From: Peter Sims [psims@ninyoandmoore.com]
Sent: Thursday, November 06, 2014 1:51 PM
To: Wickham, Jerry, Env. Health
Subject: RE: Ashland Housing Project
Attachments: Building A Excavation Sampling Locations.pdf; DTSC Fill Guidelines SMP_FS_Cleanfill-Schools.pdf

The Ashland contractor has asked me to perform additional characterization of 2,777 cubic yards of soil to be excavated beneath Building A (highlighted on the attached figure) to a depth of 5 feet bgs. We would like to sample the soil in-situ to determine if it is suitable for reuse on site or off-site waste disposal classification. Since we did not discuss in-situ sampling for soil reuse/disposal in our IRAP, I would like to perform the sampling as described below based on the DTSC Fill Guidelines (attached).

ASHLAND FAMILY HOUSING
 KENT AVE. AND E. 14TH STREET
 ASHLAND, CA

**GRADING PLAN:
 CONSTRUCTION
 NOTES**

CHECKED: CW
 SCALE: 1"=20'
 SHEET NUMBER: **C-4.2**

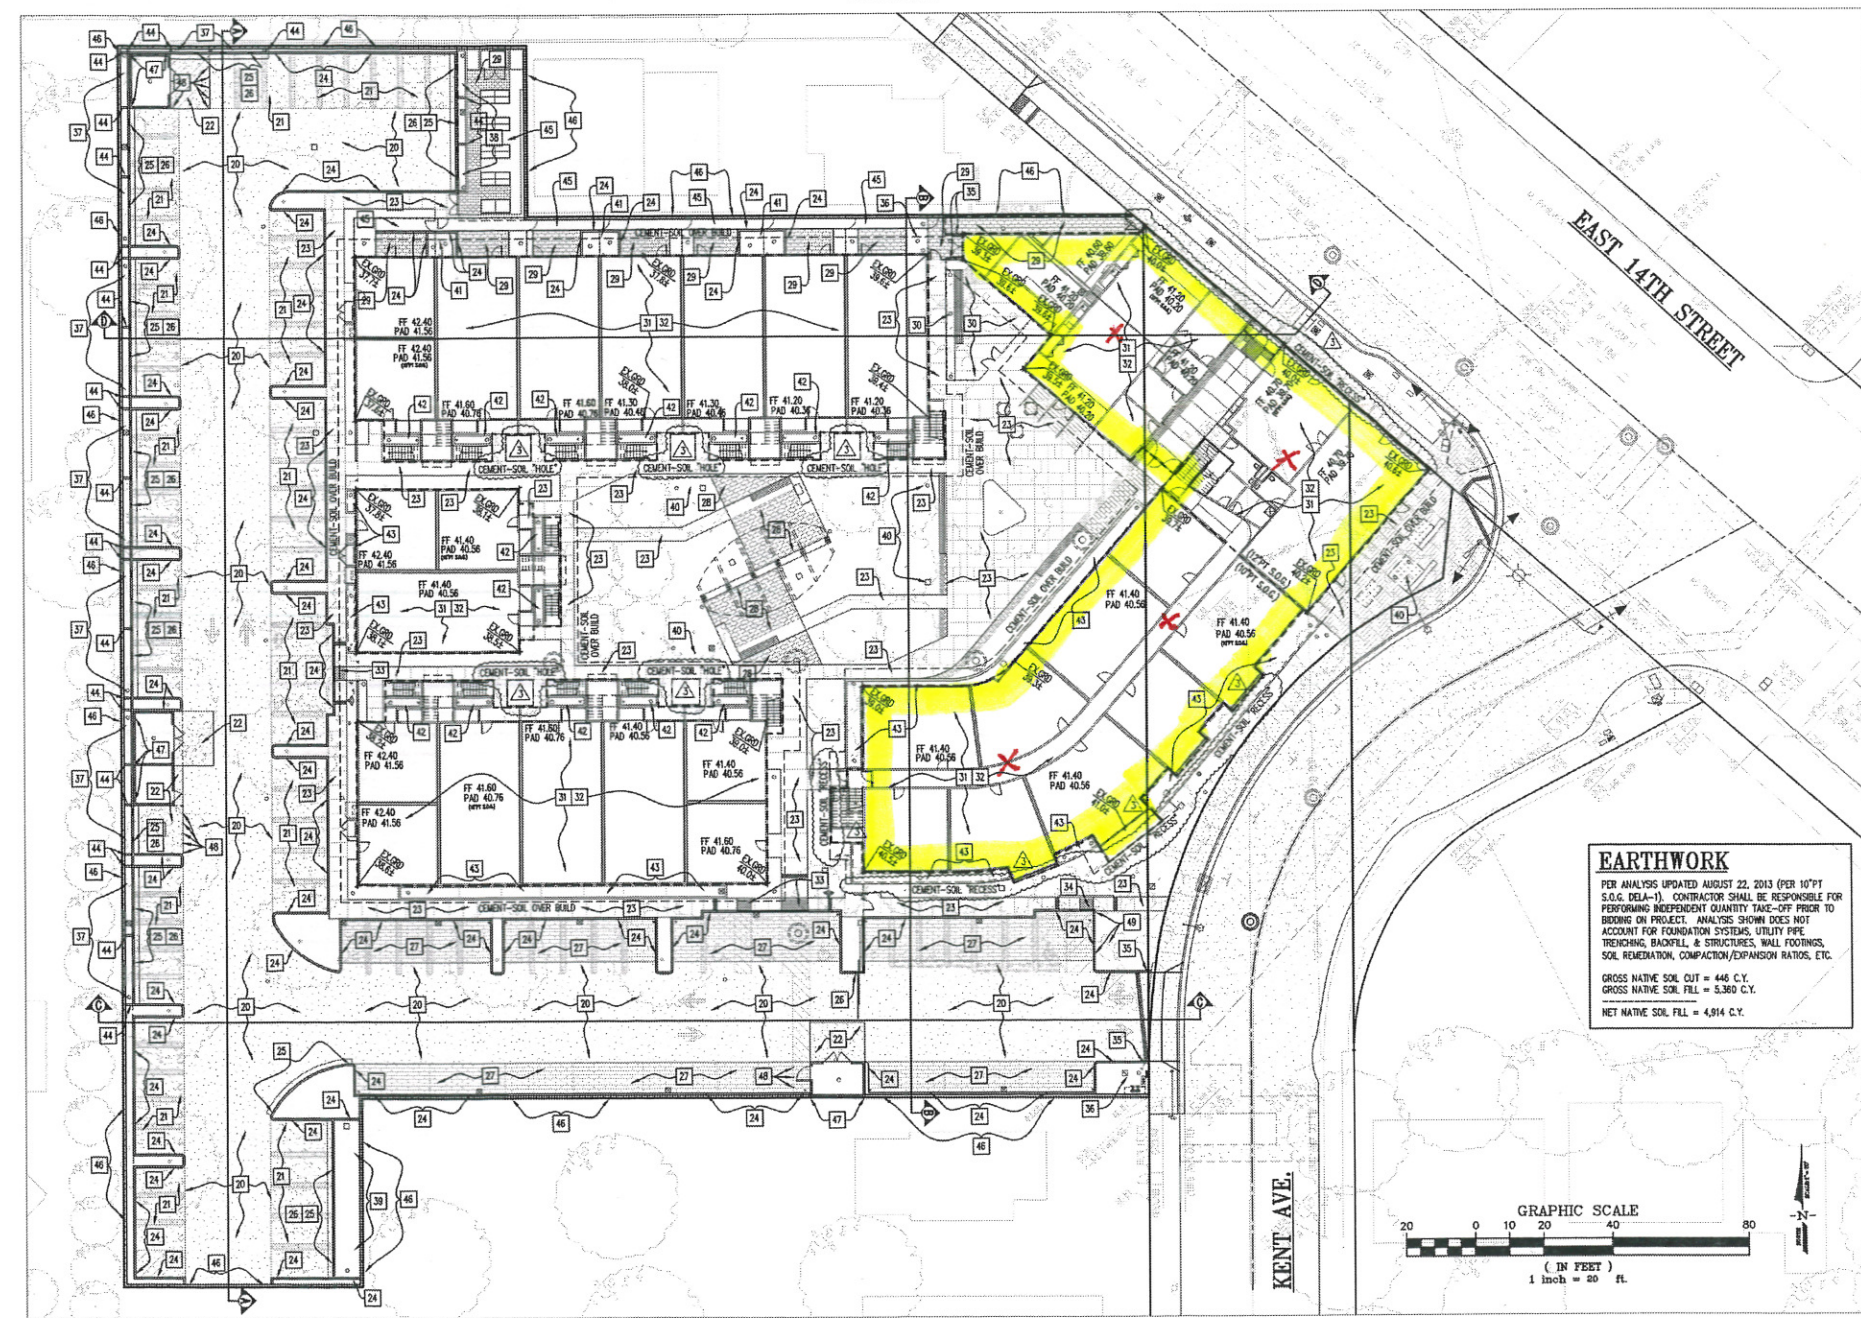
Advance four borings (shown on the attached figure) to 5 feet bgs for the collection of soil samples at 0, 1.5, 3, and 5 feet bgs in each boring.

Samples from the same depths will be combined into four 4-point composite samples by the laboratory.

The four 4-point composite samples will be analyzed for TPHd and TPHmo by EPA 8015 and Title 22 Metals by EPA 6010/7471.

One discrete sample per boring (each collected at different depths) would be analyzed for BTEX and TPHG by EPA 8260B.
